HISTORIC PRESERVATION BOARD

HISTORIC PRESERVATION BOARD MEETING

PUBLIC HEARING
28 SAINT LAWRENCE STREET

WORKSHOP
102 STATE STREET (Winter Street frontage)

Proposed Elevations

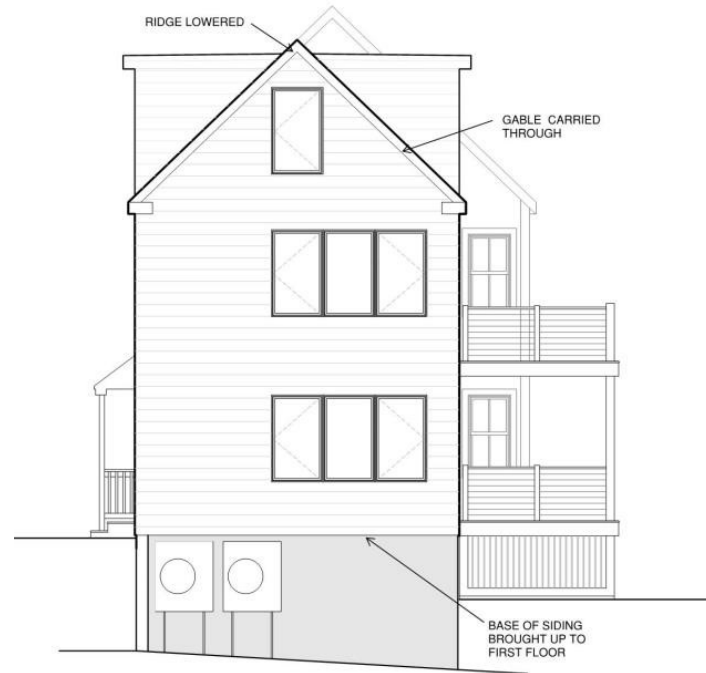
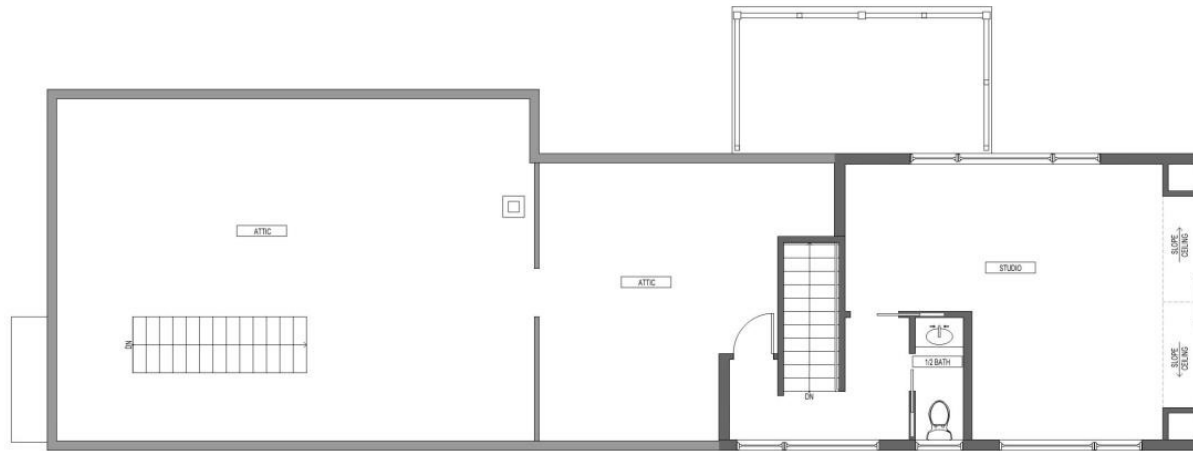
Staff notes that as result of the efforts to reduce height and mass and the need to assure useable headroom, the two new dormers will have roofs that are almost flat. While dormers with slightly more pitch would present a more typical profile, the geometry does not permit that. This profile is more visible in elevation drawings than in actual ground-level views, and though the west elevation will be quite visible from Waterville Street, the dormers are slightly set back from gable's rake, and the observer on Waterville will be looking up at the building because of the change in elevation.

Fenestration, siding, and other elements on the new dormers and rear ell make those sections clearly differentiated from the original house, and staff wonders if the character is so different that it makes for a tenuous relationship between new and old. Are there ways in which details such as fenestration patterns could be modified to enhance a more comfortable compatibility, while maintaining a clearly contemporary aesthetic approach? For example, there is no relationship at all between the fenestration in the north dormer and the windows on lower floors. On the south side, one wonders if it might appear as if a

rear section of a completely different character has been attached to a quite traditional historic house. It is important to establish the differentiation, but perhaps window patterning or other subtle qualities could enhance the relationship between contemporary and traditional sections.

- South dormer shortened by c. 4' at east and 2' at west.
- Continued existing eave past south dormer to break up massing.
- Now reads as dormer in roof plane and not as monolithic mass.
- West elevation roof line extends existing gable profile, with dormers inset.
- Ridge height of addition lowered to height of existing wing.
- Siding changed to horizontal to de-emphasize vertical read.

- North dormer extended over new addition and expressed as part of new work.
- Trim reduced or eliminated.
- Large exposure siding in new work.

Existing trim details

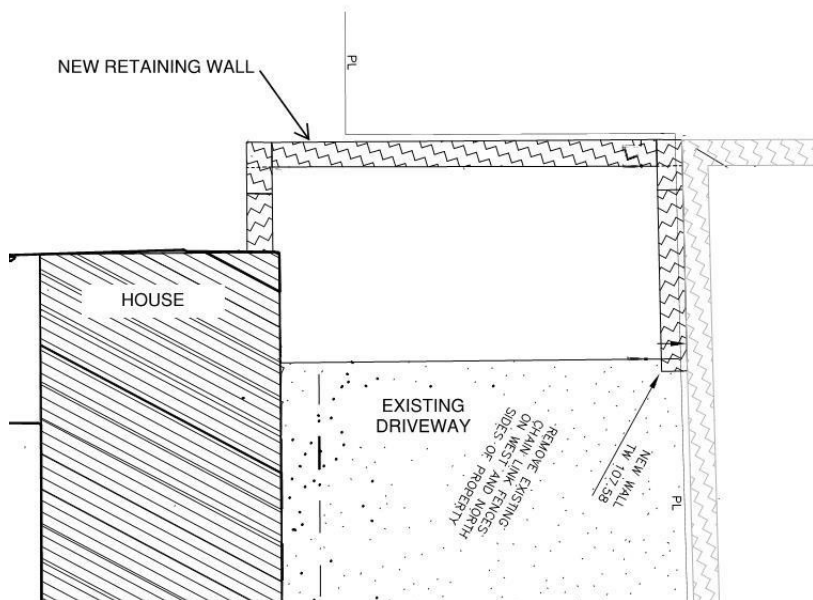
- Do explore what is known about the historic details of the house, including:
 - Verifying the surviving trim that may remain under modern claddings, to assure authentic recreations

- We removed some of the aluminum wrap to reveal the existing window and door trim to be replicated.

End of driveway retaining wall

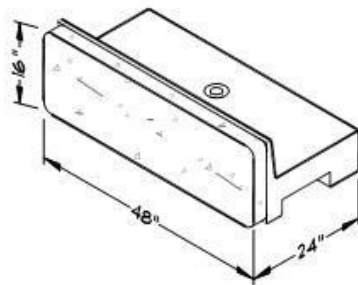
- Consider a simple, contemporary version of a hood for the north side entry door, where there is currently a shed-roofed hood.
 - Details are needed on the retaining wall at the end of the north driveway, that is to connect with and be similar to the existing wall next door at 32 St. Lawrence.

1 VIEW FROM SPRING STREET

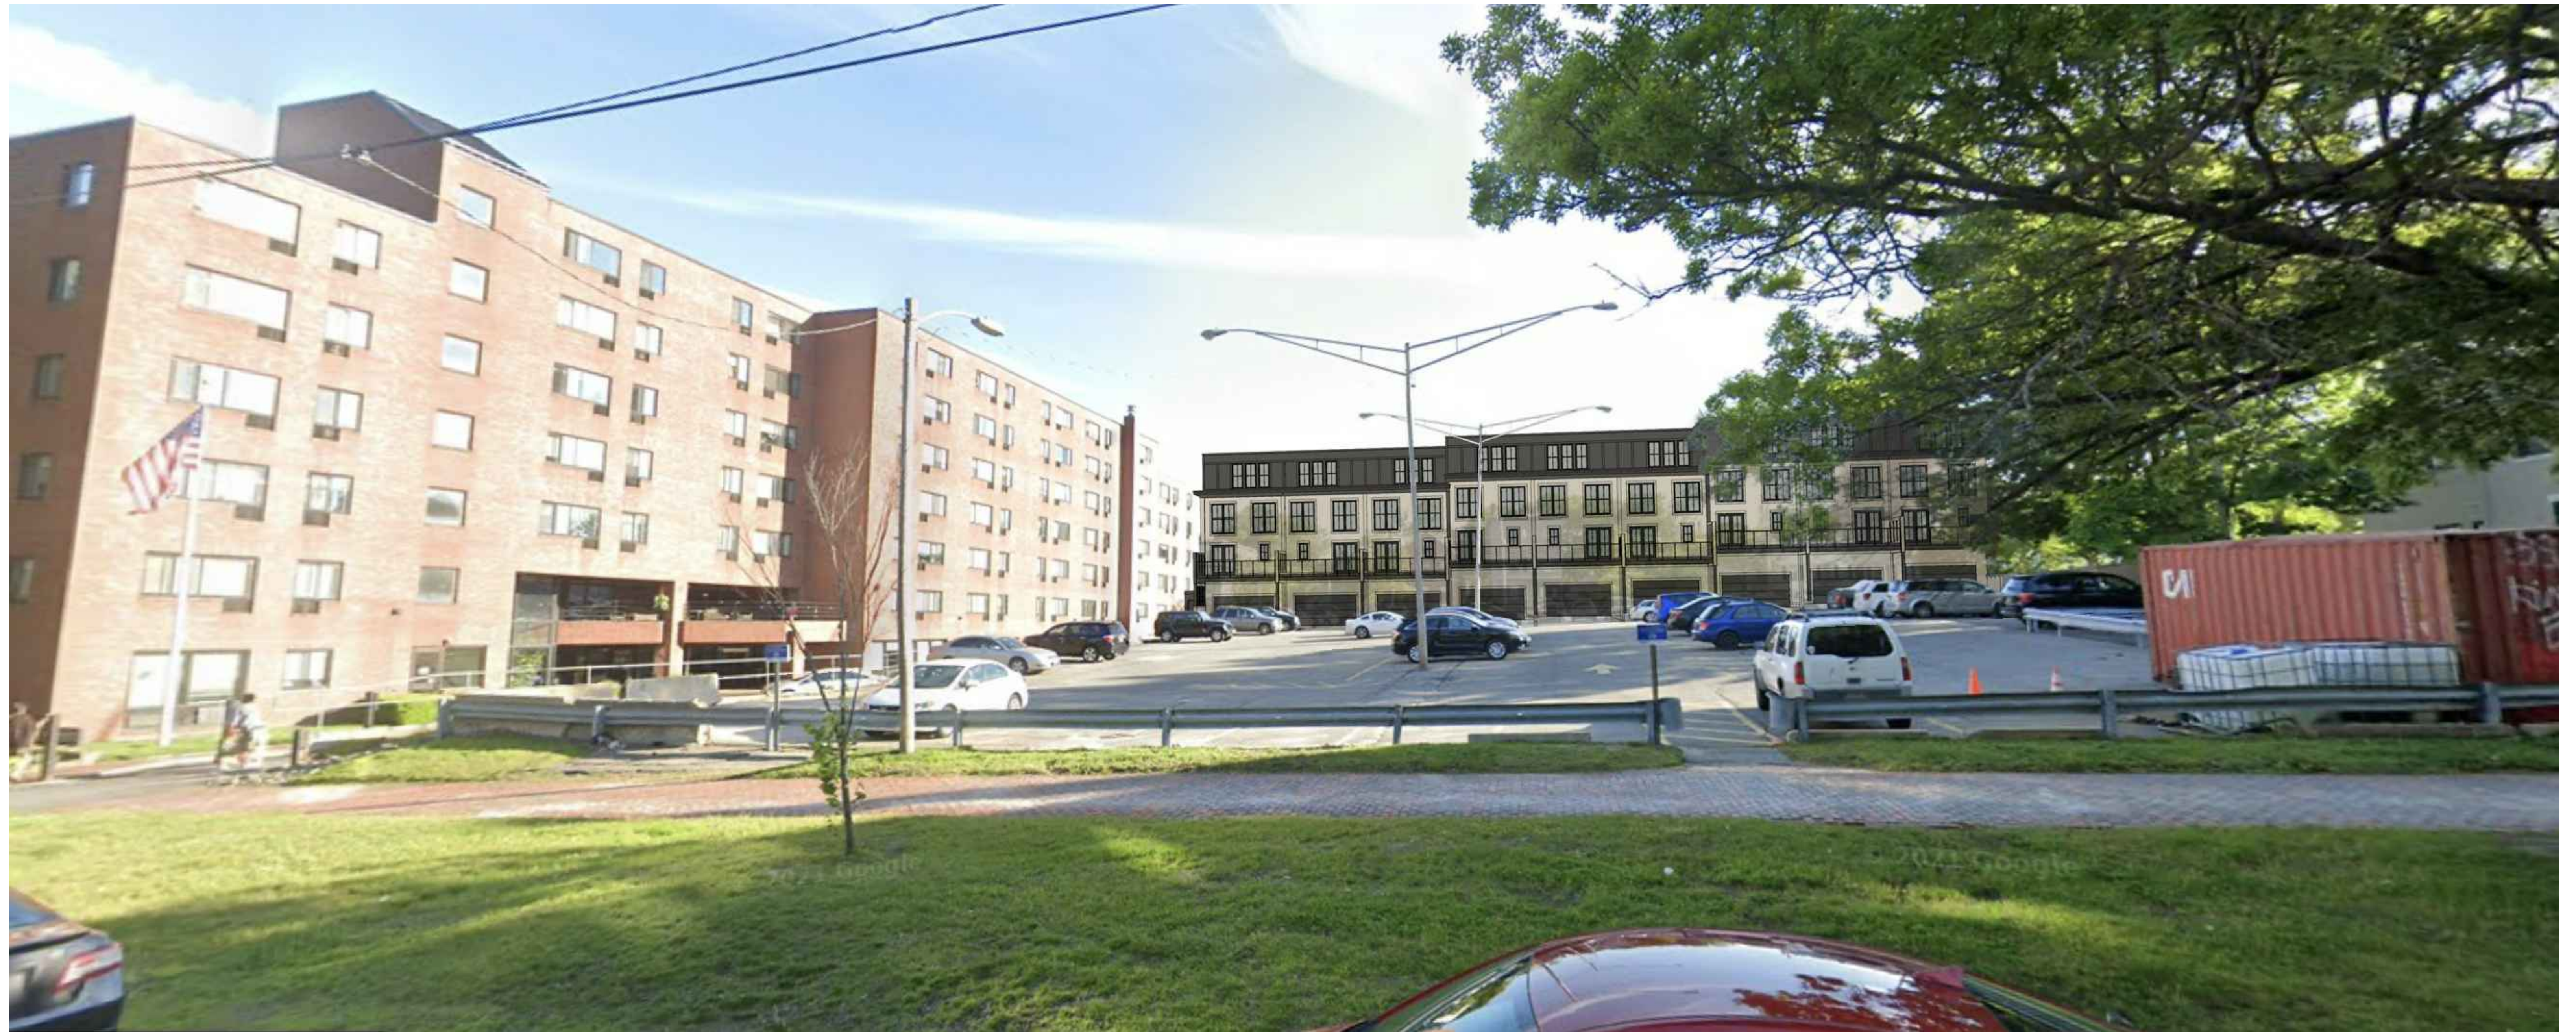
- It would be helpful to see a rendering of the project as one approaches from the east on Spring Street. Given that there will be a driveway behind the development, the rear of the building will be clearly visible. (Obviously, it will be clearly visible from State Street as well, at least until or unless the front portion of the lot is developed.)
